Access Compliance Report Public Rights-of-Way (Curb Ramps)

Main Street: MONTECITO_RD		Cross Street: TUCKER_LN		Location:	SW
ADA ID: RPRK211208113335	Ramp Type: Type 4 - Parallel	Initial Pass/Fail: Fail	Overall Compliance: No	Severity Score:	30
Codes/Mitigation Info/Possible Solution			Field Measurements/Component Compliance

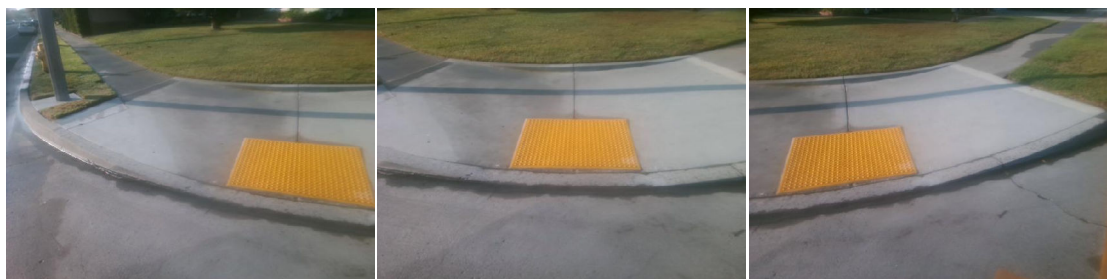
Compliance	Description	Data	Compliance	Description	Data
N/A	Ramp Length LT (in)	114	N/A	Ramp Length RT (in)	105
Yes	Ramp Width LT (in)	110	Yes	Ramp Width RT (in)	110
Yes	Ramp Run Slope LT (%)	1	Yes	Ramp Run Slope RT (%)	7.4
No	Ramp Cross Slope LT (%)	3.7	No	Ramp Cross Slope RT (%)	7.6
N/A	Landing Present	N/A	N/A	DWS Provided	N/A
N/A	Landing Length (in)	N/A	N/A	DWS Contrast	N/A
N/A	Landing Width (in)	N/A	N/A	DWS Length (in)	N/A
N/A	Landing Run Slope (%)	N/A	N/A	DWS Full Width	N/A
N/A	Landing Cross Slope (%)	N/A		DWS Offset Type	N/A
N/A	Landing Movement Obstructed?	N/A	N/A	DWS Offset Left (in)	N/A
	Landing Movement Type	N/A	N/A	DWS Offset Right (in)	N/A
N/A	Landing Shared	N/A			
N/A	Clear Space	Yes			
N/A	Clear Space To Crosswalk (in)	N/A			
N/A	Marked Crosswalk 1	No	N/A	Marked Crosswalk 2	Yes
	Crossing 1 Direction	E		Crossing 2 Direction	N
	Marked Crosswalk 1 Width (in)	N/A		Marked Crosswalk 2 Width (in)	144

Remove & Replace Curb Ramp With Two New Directional Ramps or Equivalent.
